SUITE 311
ORIGINAL
LAYOUT
INVENTORY
SUITE

**SUITES 311 - NOYAK BAY**

■ Royal Pine Homes ■ 25 Baker Hill Blvd - Storffville, ON ■ Feb 14, 2018

DRAWING AS PER AGREEMENT OF PURCHASE AND SALE (before decor appointment)

NOYAC BAY: 311

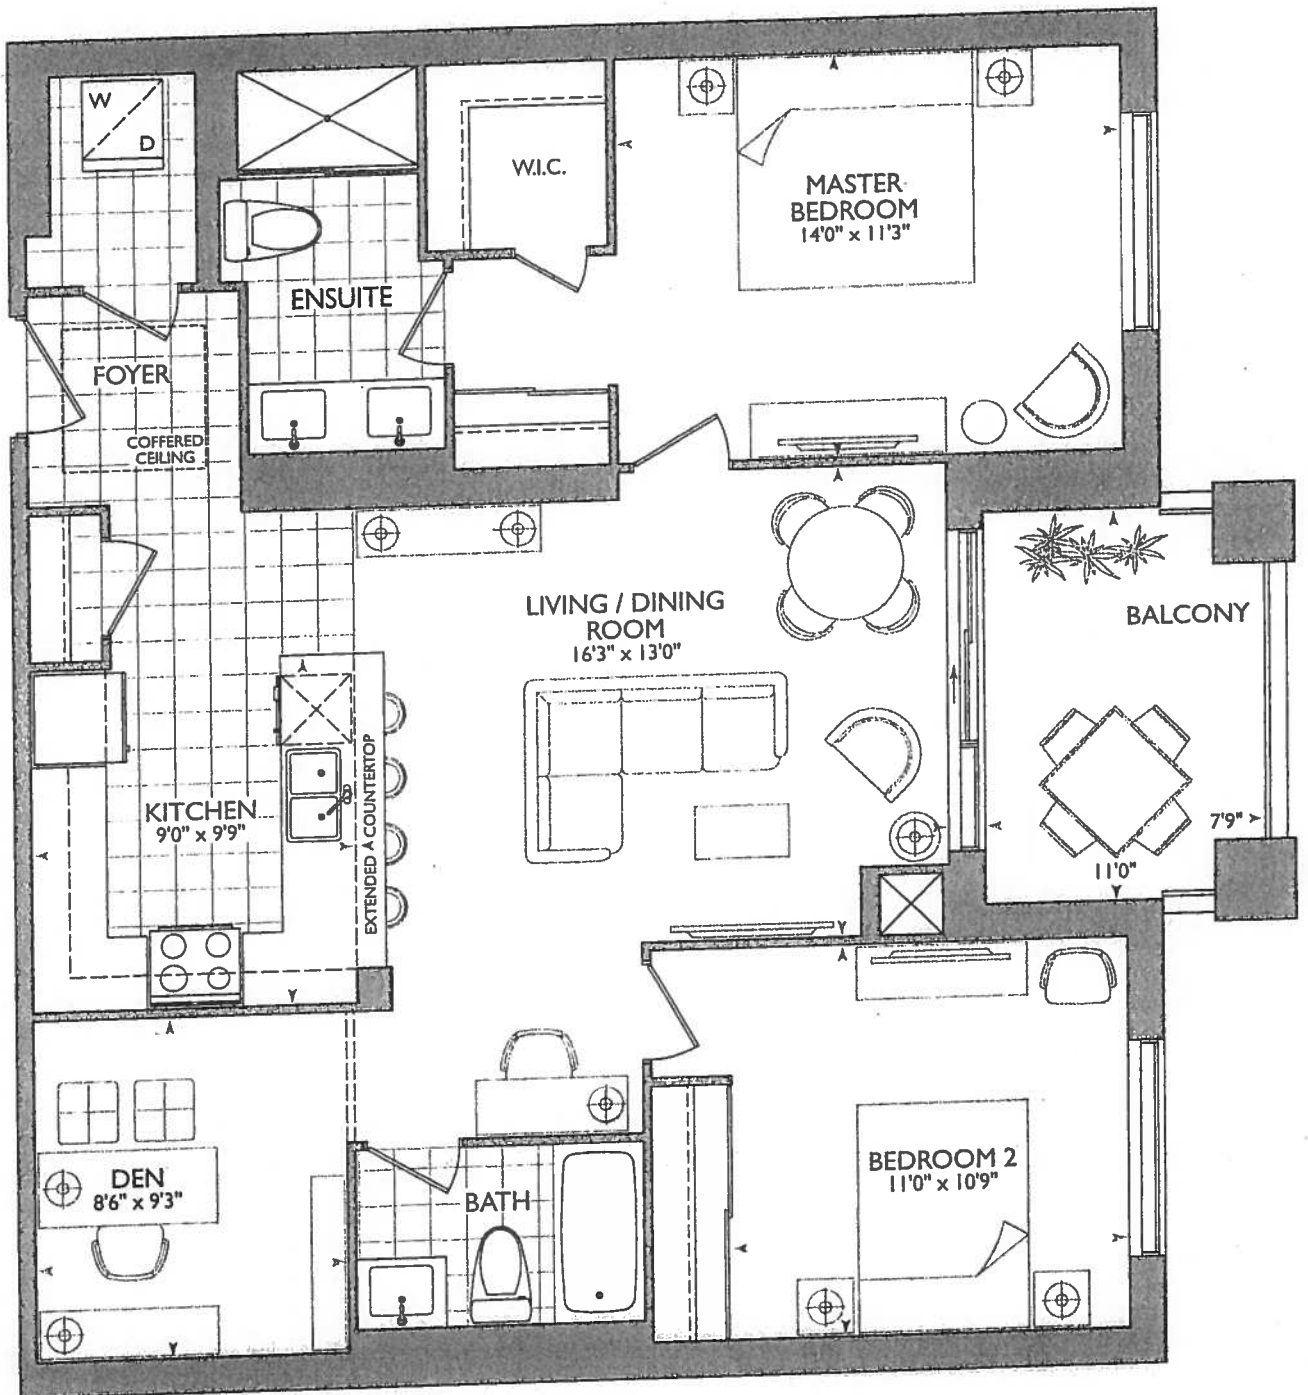
- ENSUITE WALL REVISED AS PER ARCHITECTURE DRAWINGS
- LAUNDRY DOOR SWING TO OPEN AGAINST THE ENSUITE WALL
